Access Compliance Report

Public Rights-of-Way

Intersection ID: 49308	Main Street: PANGLE_DR	Cross Street: JOSHUA_LN	Location: SW
ADA ID: 94276BB81545	Ramp Type: BlendTrans1	Initial Pass/Fail: Fail	Overall Compliance: No
Severity Score: 21.25			
Codes/Mitigation Info/Possible Solution		Field Measurements/Component Compliance

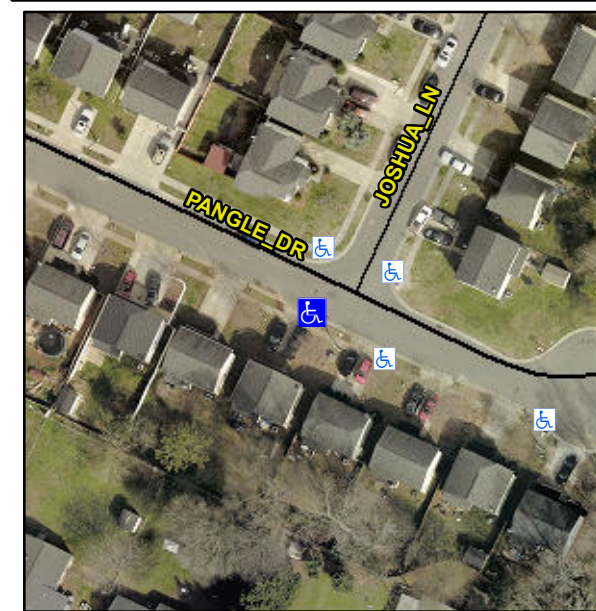
Remove & Replace Curb Ramp With Two New Directional Ramps or Equivalent.

R304.5.1, R304.5.3

Compliance	Description	Data	Compliance	Description	Data
N/A	Ramp Length (in)	46.0	Yes	BlendTrans Slope (%)	4.6
No	Ramp Width (in)	47.0	No	BlendTrans XSlope (%)	5.1
N/A	Flare Type LT	N/A	N/A	Flare Type RT	N/A
N/A	Flare Slope LT (%)	N/A	N/A	Flare Slope RT (%)	N/A
N/A	Flare Traversable LT?	N/A	N/A	Flare Traversable RT?	N/A
N/A	Landing Length (in)	N/A	N/A	DWS Provided?	N/A
N/A	Landing Width (in)	N/A	N/A	DWS Contrast?	N/A
N/A	Landing Slope (%)	N/A	N/A	DWS Length (in)	N/A
N/A	Landing X Slope (%)	N/A	N/A	DWS Full Width?	N/A
N/A	Landing Curb? (Y/N)	N/A	N/A	DWS Offset (in)	N/A
N/A	Shared Landing?	N/A			
N/A	Gutter Ponding?	N/A	N/A	Gutter Slope (%)	N/A
N/A	Gutter Lip Ht (in)	N/A	N/A	Gutter X Slope (%)	N/A
N/A	Painted X Walk1?	No	N/A	Painted X Walk2?	N/A
	X Walk 1 Direction	To N		X Walk 2 Direction	N/A
	X Walk 1 Width (in)	N/A		X Walk 2 Width (in)	N/A
	X Walk 1 Slope (%)	1.6		X Walk 2 Slope (%)	N/A
	X Walk 1 X Slope (%)	5.2		X Walk 2 X Slope (%)	N/A
